Release Note LS-400 VA1 v2.11.21.68

(This version is only compatible with the new HW version – VA1)

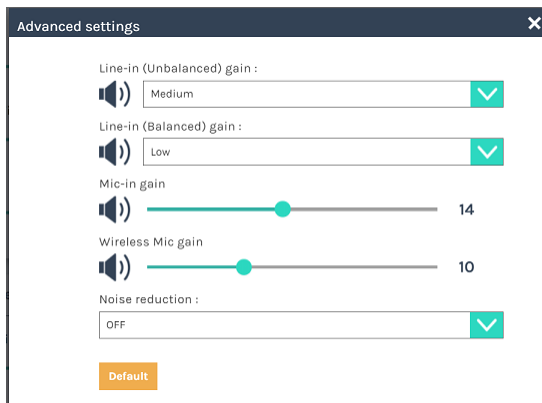
1. Differential audio input with phoenix type connector is “only” available on **LS-300**, **LS-400** and **KL-3T**.
2. Audio Noise Reduction (Line-in/Mic-in)  
It can reduce the background noise that is present in recordings.
3. Audio Gain Control (Line-in/Mic-in)  
Both balanced (Phoenix) and unbalanced (3.5mm) audio inputs have “Gain Control”.
  - Line-in (Unbalanced/Balanced): 3-step gain – Low, Medium, High
  - Mic-in/BT-Mic: 30-step gain

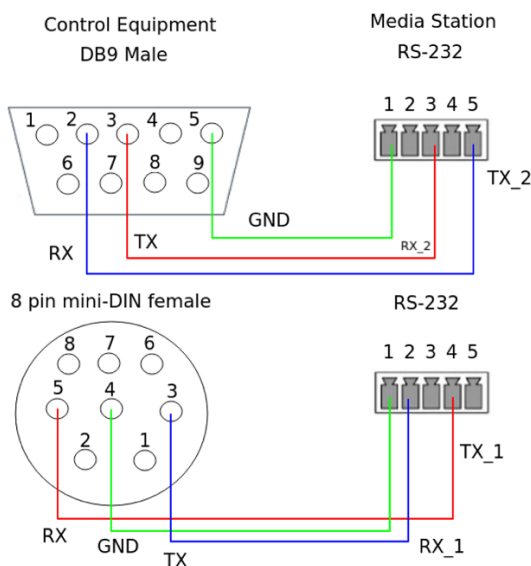
4. Equipped with one RE-232 camera control port  
The same RS-232 port can now send commands for camera control while receiving commands from control systems.  
\* It can only control one camera, for additional cameras, USB-RS-232 cables will still be needed.
